RENESAS TECHNICAL UPDATE

Product Category	MPU/MCU		Document No.	TN-RH8-A0004A/E	Rev.	1.00
Title	RH850/D1x Flash Memory User's Manual Change		Information Category	Technical Notification		
Applicable Product	RH850/D1x	Lot No.	Reference Document	RH850/D1x Flash Memory User's Manual: Hardware Interface (R01UH0523EJ0110 Rev.1.10)		
		All

Figure 6.22 Flow of Reading of the Configuration Setting Area

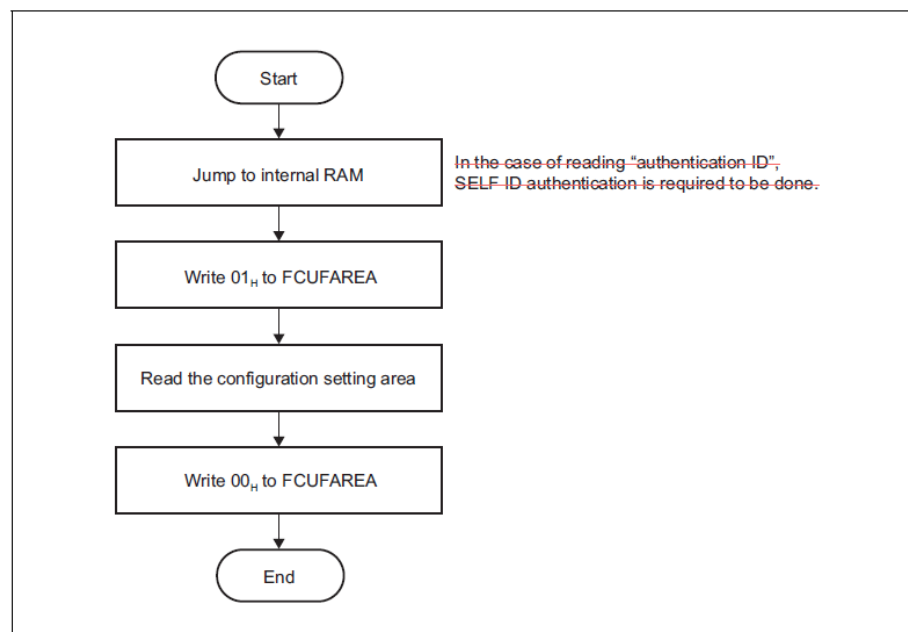
The following parts that are canceled with a red line are unnecessary.

~~A configuration setting "authentication ID" stored area cannot be read without SELF-ID authentication.~~
